Response to reviewer 2

Review of egusphere-2026-4631: “Derivation of the multi-Doppler 3D wind field during the 2023 WesCon-WOEST campaign in southern England” by Thompson et al.

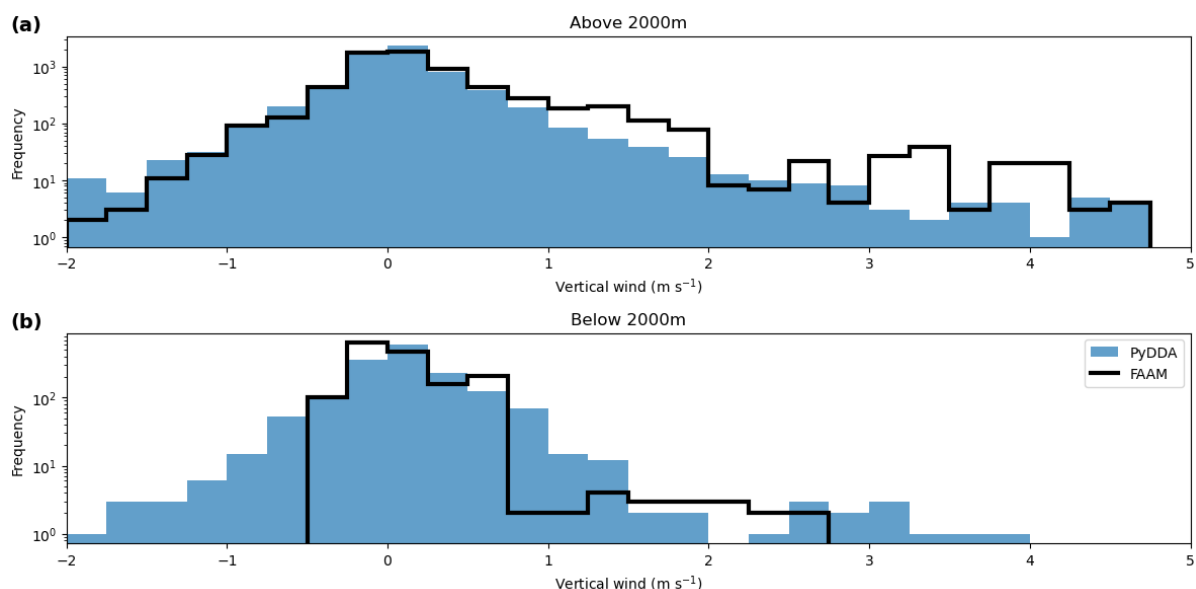
Fig. 9: A log y-axis would be more appropriate since some of the most important differences are in the histogram tails.

Quantisation becomes an issue with this plot with a logarithmic axis, making interpretation harder as can be seen in the figure below. The above 2000m histogram shows the PyDDA method has slightly less of the strongest updrafts, below 2000m this is less certain, though quantisation and representativity are both concerns. There is a likely a factor of representivity similar to a radar-gauge comparison: while averaging has helped extend the aircraft’s point measurement to a line, it remains essentially 1 dimensional, compared to a 3D volume defined by the multi-Doppler grid. We believe that the linear version is a fairer assessment of the true data and it’s representativity.
